AMENDMENT TO FACILITY OPERATING LICENSE

Amendment No. 50
License No. DPR-39

Amendment No. 47
License No. DPR-48

ATTACHMENT TO LICENSE AMENDMENTS

Figure 3.3.2-1

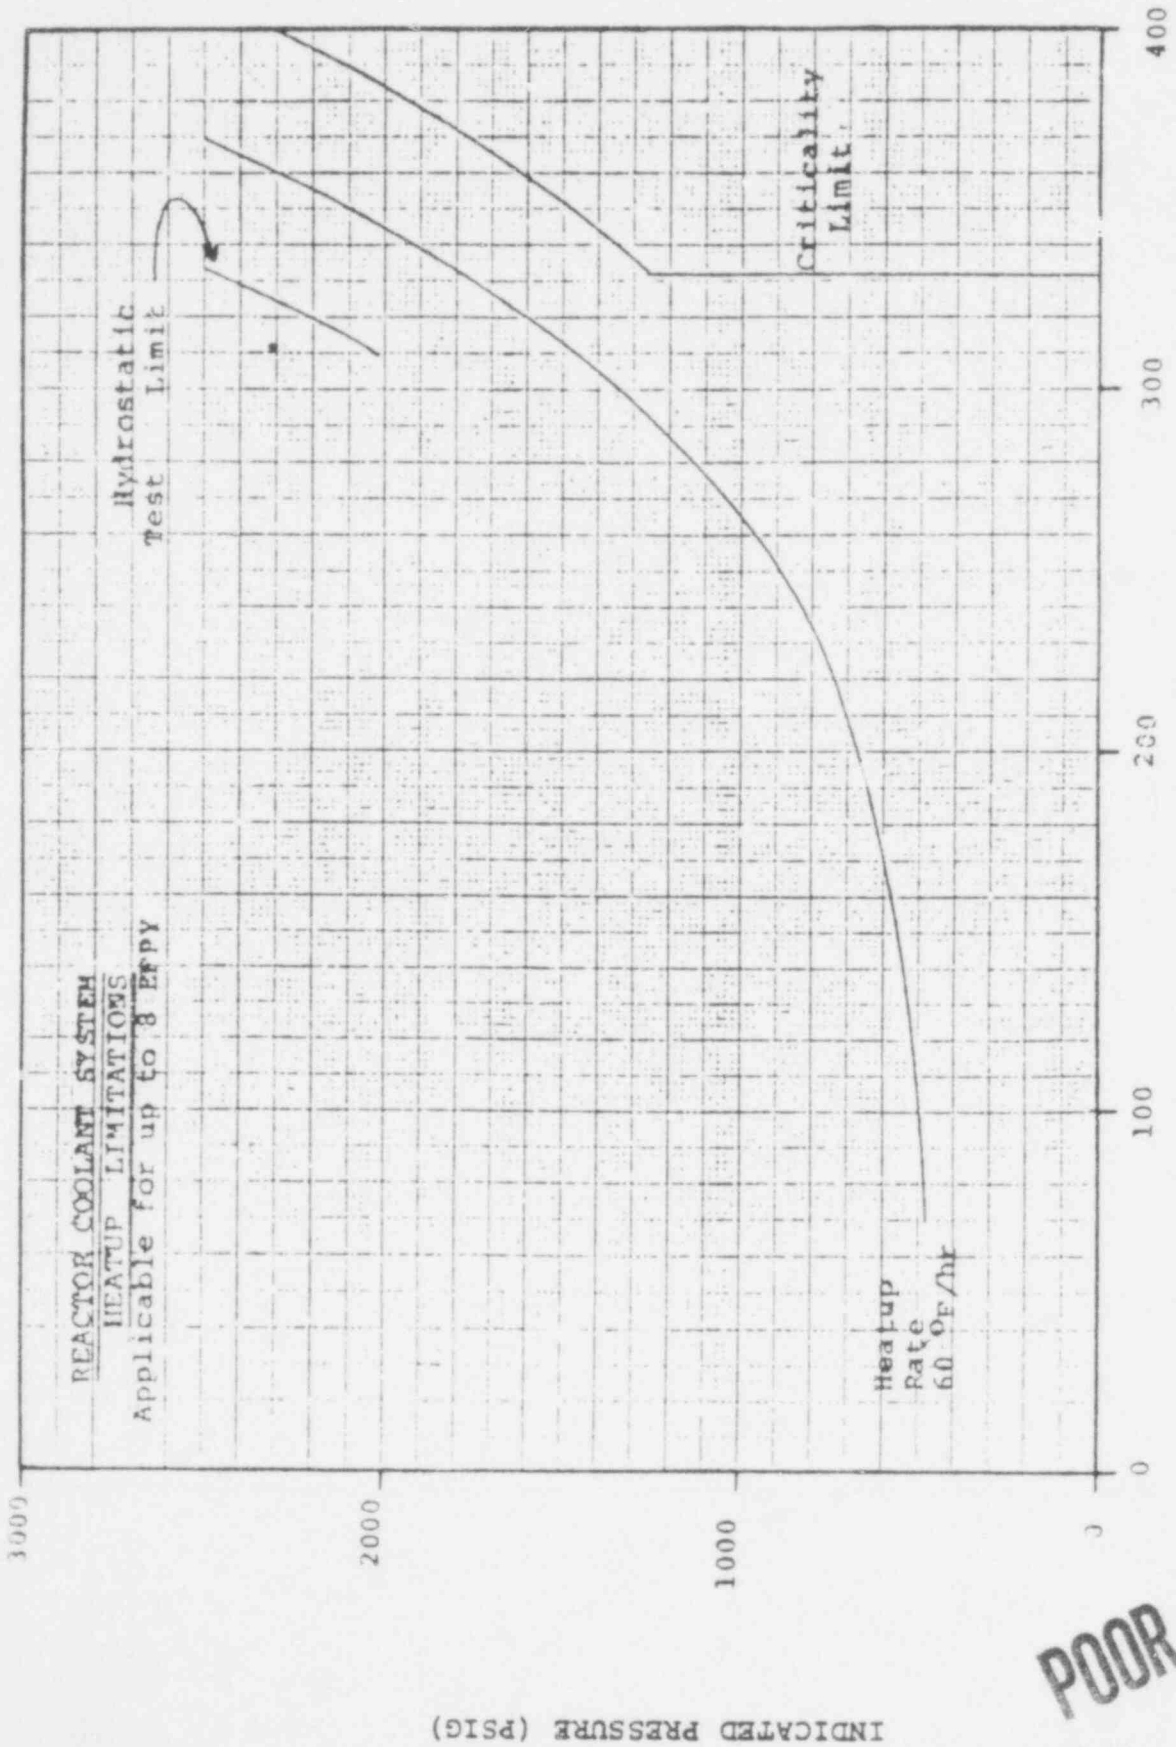
The Reactor Coolant System temperature and pressure (with the exception of the pressurizer) shall be limited in accordance with the limit lines shown in Figures 3.3.2-1 and 3.3.2-2 during heatup, cooldown and inservice leak and hydrostatic testing.

1. Allowable combinations of pressure and temperature for specified temperature change rates are below and of the right of the limit lines shown. Limit lines for cooldown rates between those presented may be obtained by interpolation.
2. Figures 3.3.2-1 and 3.3.2-2 define limits to assure prevention of non-ductile failure only. For normal operation other inherent plant characteristics, e.g., pump heat addition and pressurizer heater capacity may limit the heatup and cooldown rates that can be achieved over certain pressure-temperature ranges.
3. The Reactor Coolant System shall be limited to a maximum temperature change of 10°F/hr during inservice

- B. The limit lines shown in Figures 3.3.2-1 and 3.3.2-2 shall be recalculated periodically as required based on results from the material surveillance program.
- C. The secondary side of the steam generator must be pressurized above 200 psig if the temperature of the vessel is below 70°F.
- D. The pressurizer heatup rate shall not exceed 100°F/hr and the pressurizer cooldown rate not exceed 200°F/hr. The spray shall not be used if the temperature difference between the pressurizer and the spray fluid is greater than 320°F.
- E. Hydrostatic Testing
 - 1. System inservice leak and hydrotests shall be performed in accordance with the requirements of ASME Boiler and Pressure Vessel Code, Section XI, 1974 Edition, up to and including Summer 1975 Addendum.

FIGURE 3.3.2-3

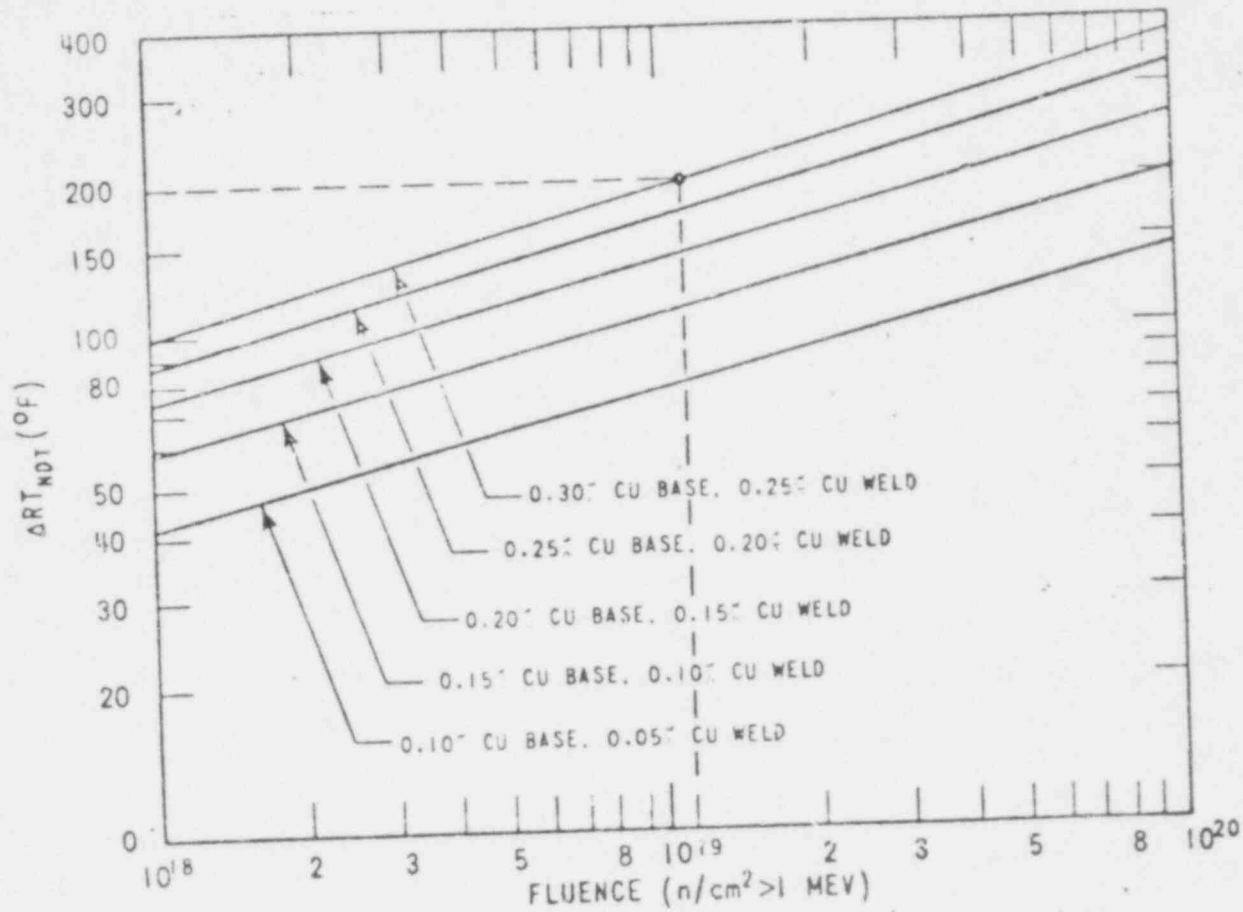
1. Determine the highest RT_{NDT} of the material in the core region of a reactor vessel using original values from Table 3.3.2-1 and estimating the radiation induced ΔRT_{NDT} using Figure 3.3.2-3 (Reference 6 & 7).
Fast neutron ($E > 1$ Mev) fluence at the 1/4 T and 3/4 T vessel locations are given as a function of full power service life in Figure 3.3.2-4.
2. Examine the data for all other ferritic materials in a reactor coolant pressure boundary to assure that no other component will be limiting.
3. Initially, the effect of radiation on the RT_{NDT} of a reactor vessel core region material is estimated using the curves shown in Figure 3.3.2-3. The ΔRT_{NDT} shown for the first eight effective full power years is factored into the heatup and cooldown curves provided. Values of ΔRT_{NDT} determined in this manner may be used until the results from the material surveillance
